# BRAVOR BONAMAT

NO : 5.  
 TITLE : Canister spring  
 MODEL : All FreshMore dispensers  
 DATE : 10-09-2008

## Reason for sending this information

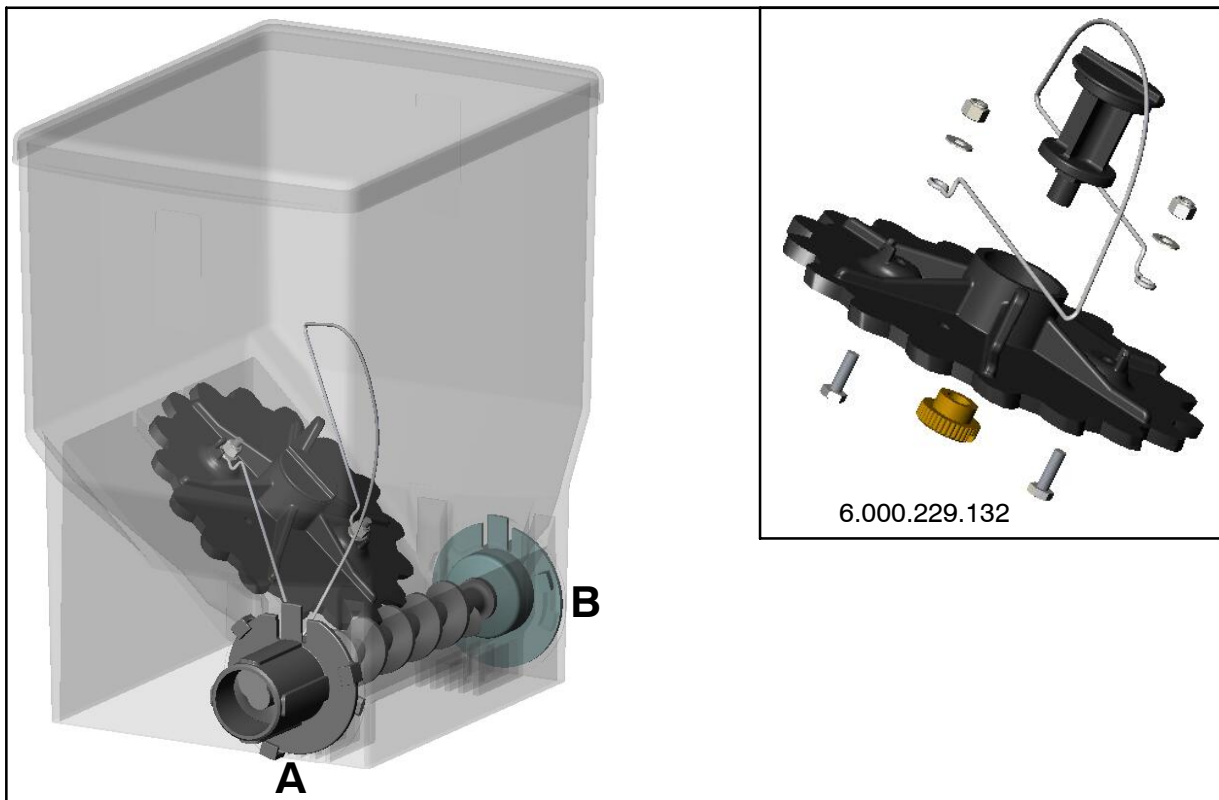
Changes within the Freshbrew-coffee canister and therefor new article number.

The old spring is replace by an other bigger one, which will prevent the tunnel effect of the Freshbrew-coffee better.

**NOTE:** For the replacement of the 6.000.229.108 dismount A and B and swap these parts then assemble again.

- 6.000.229.123 will replace 6.000.229.110 and 6.000.229.108 as Freshbrew-coffee canister
